KINN MKE GUESTHOUSE

MILWAUKEE, WI 53202

BUILDING ELEVATIONS A3.0

DESIGN REVISIONS

ADDITION ELEVATIONS A3 4

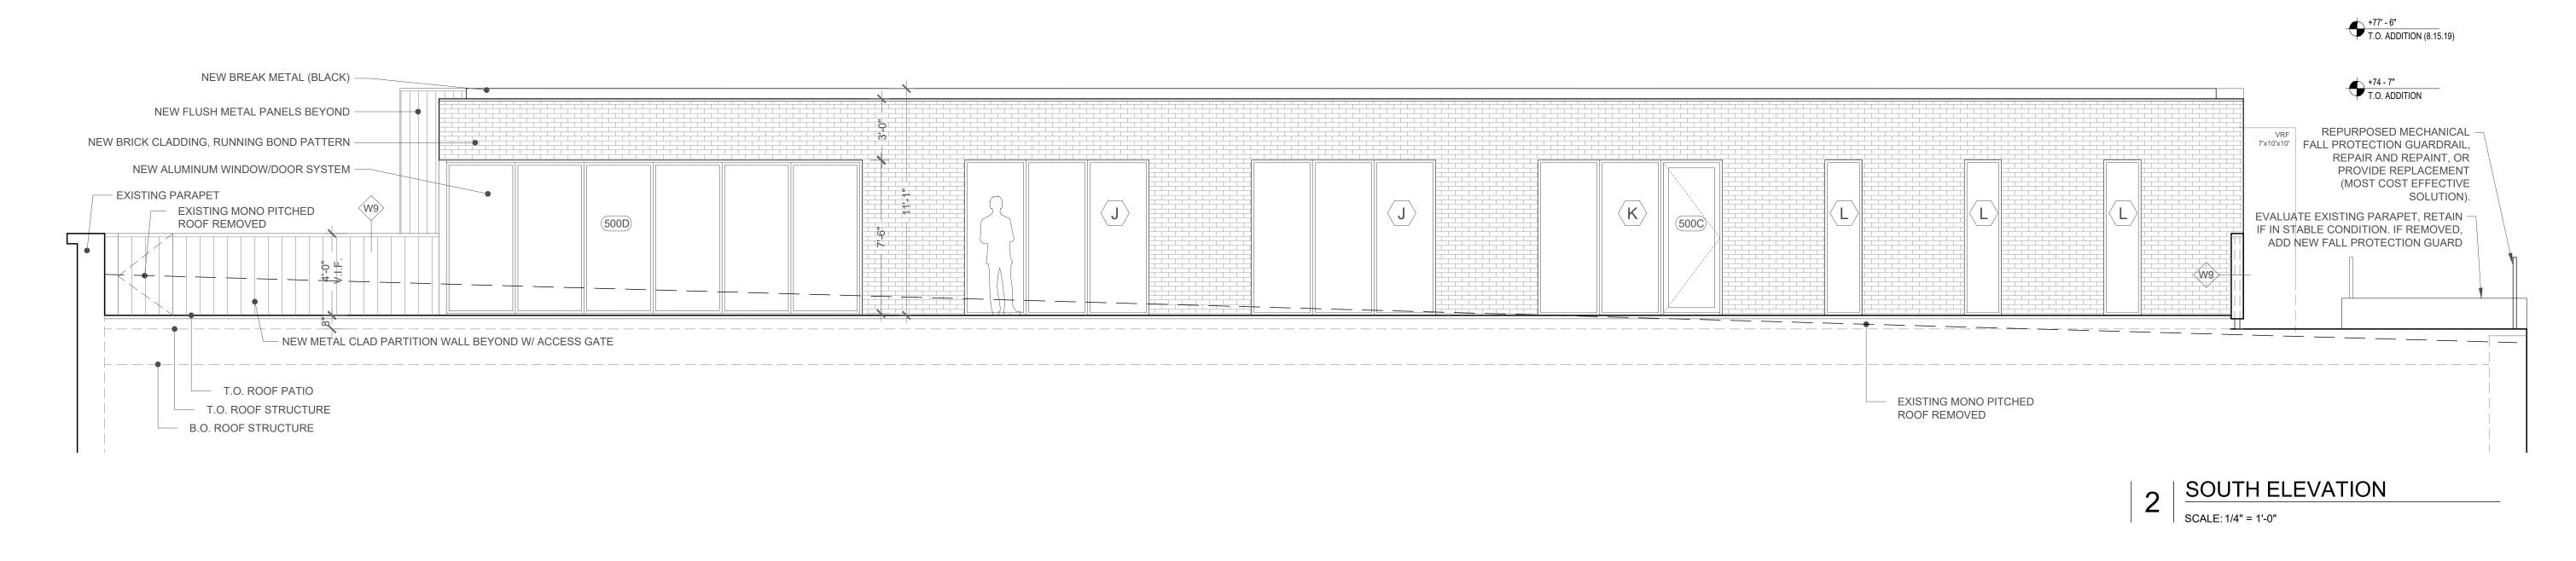
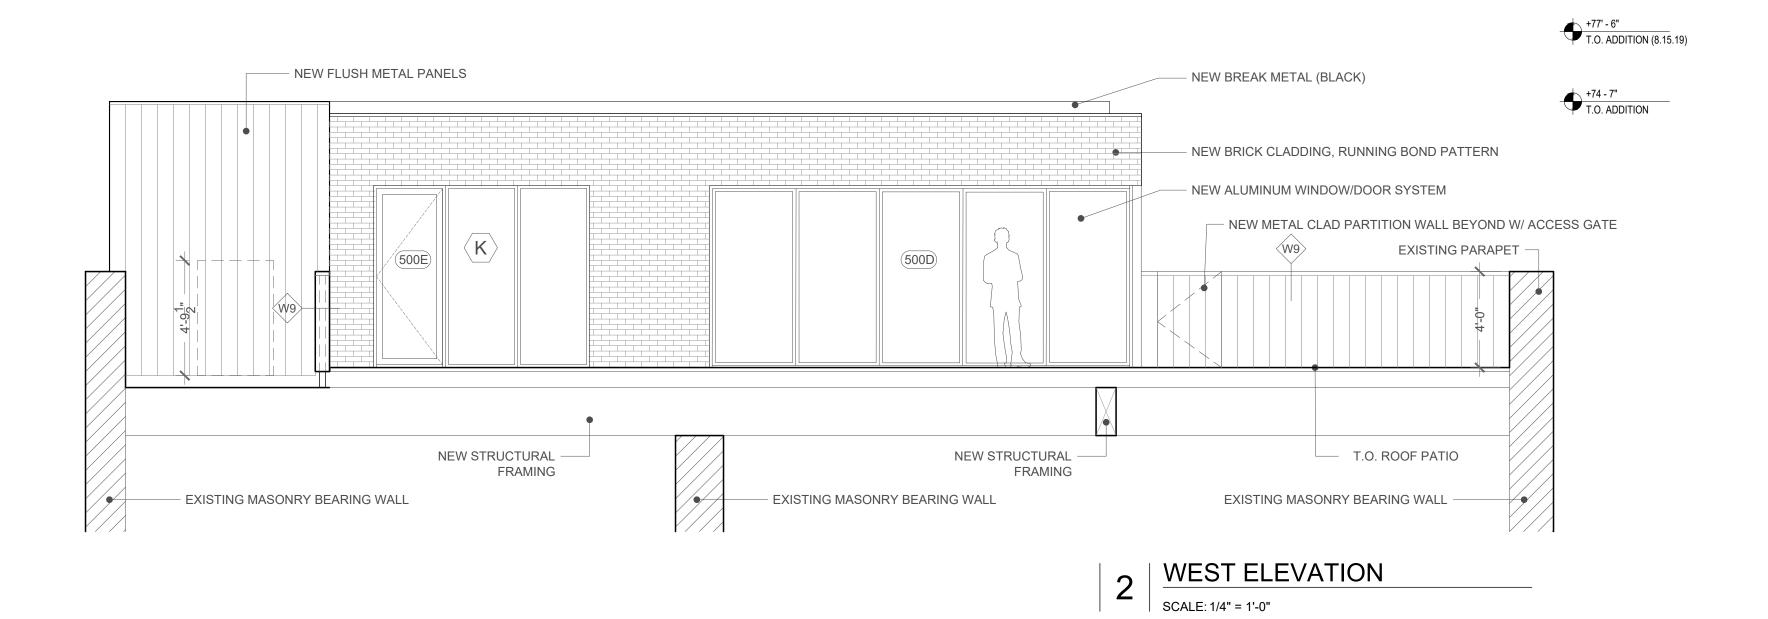
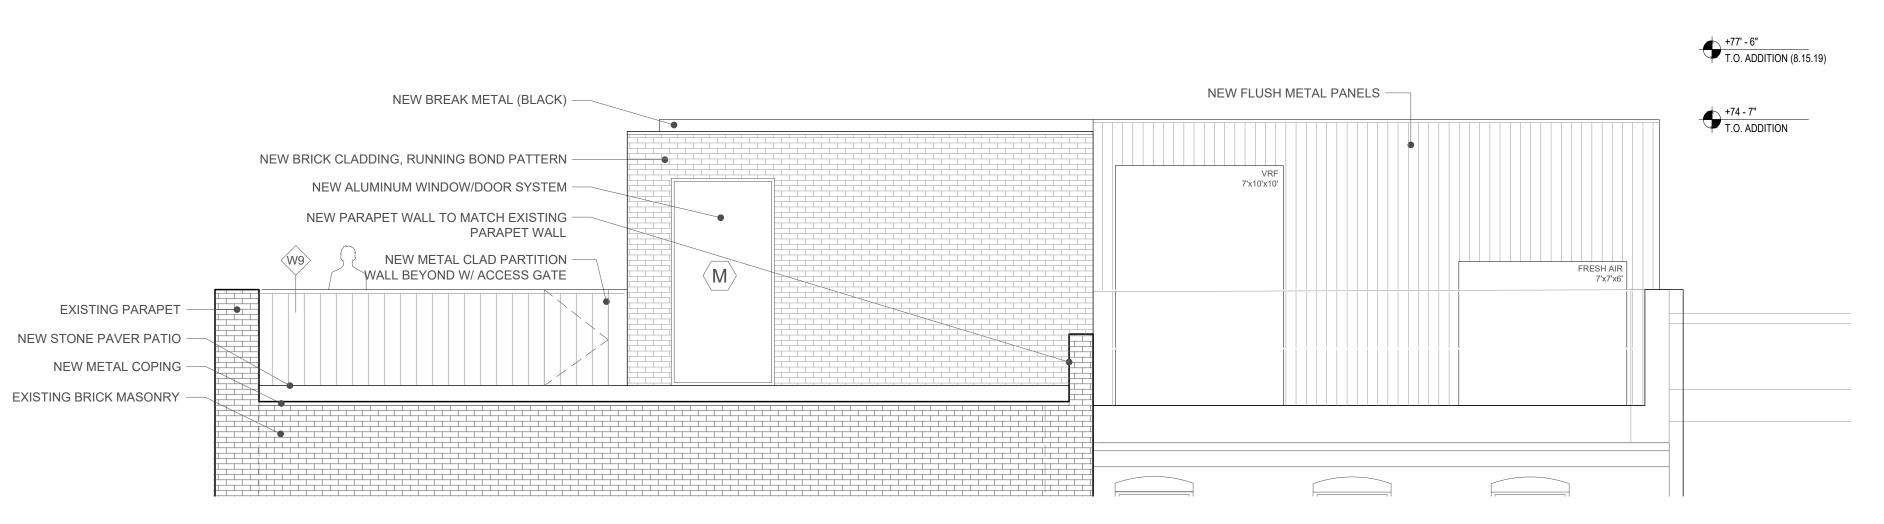
- 1. BUILDING HEIGHT REDUCED FROM 77'-6" TO 74'-7"
- 2. BRICK COLOR TONE LIGHTENED
- 3. WINDOWS REDUCED IN HEIGHT TO ALLOW FOR BRICK HEADER
